Zeus 3000 Series Pod Trim Tab Manifold—Check Valve Torque Models Affected

Models Covered	Serial Number
Zeus 3000 Series JH and KH Model Pods	0M963373–0M970295

41586

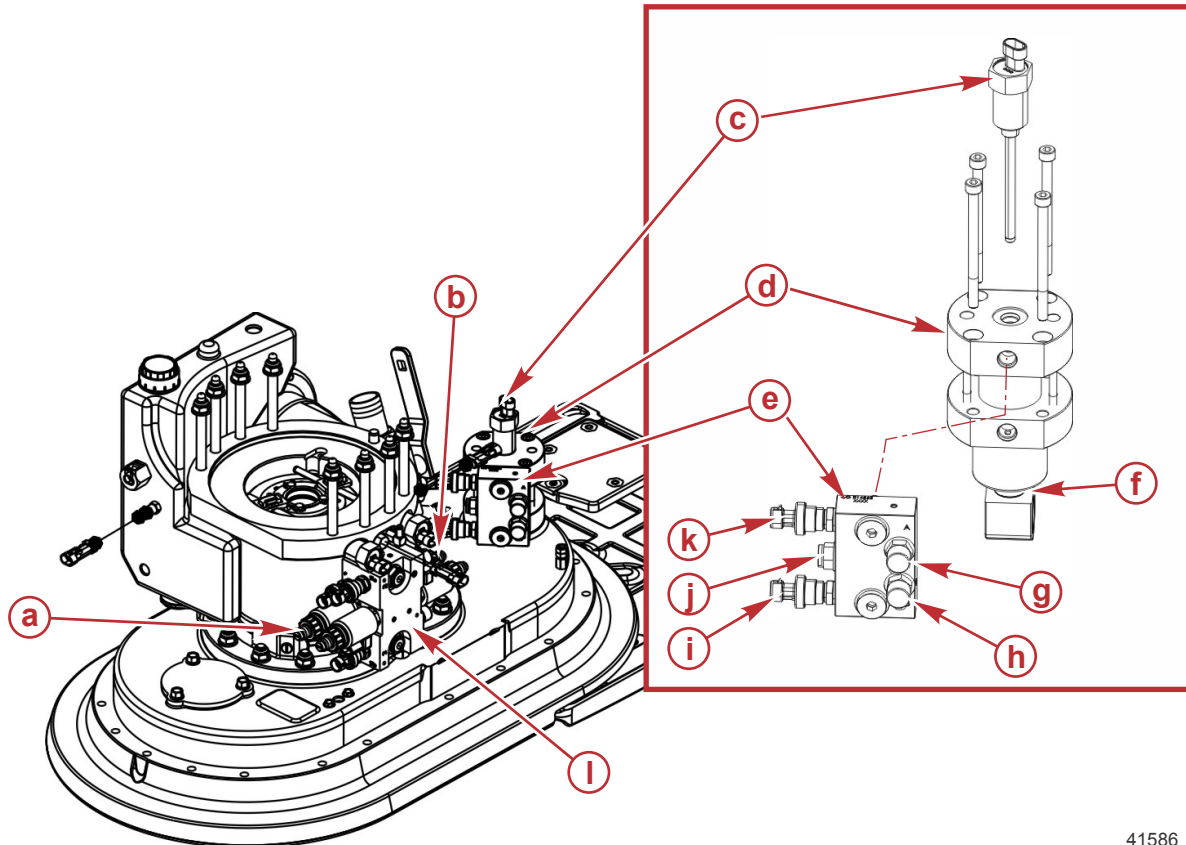
Mercury has increased the installation torque of the check valve fitting contained on the trim tab manifold assembly. Previous torque value was 29.5 lb-ft.

The new torque of 60 lb-ft was effective with pod serial number 0M970296.

Field reports have indicated that the check valve fitting may loosen over time, allowing the O-ring seal to expand out between the manifold and the check valve assembly, and thereby create a minor oil leak.

First, locate the check valve fitting on the trim hydraulic manifold assembly. See item "j" in the sketch following.

Loosen and remove the check valve fitting assembly (item "j").

Remove the O-ring (8M0088858) and inspect. Replace if necessary.

Lubricate the surface of the O-ring with the specified lubricant.

Install the check valve assembly. Tighten to the specified torque.

Description	Nm	lb-in.	lb-ft
Check valve assembly	81.35	–	60
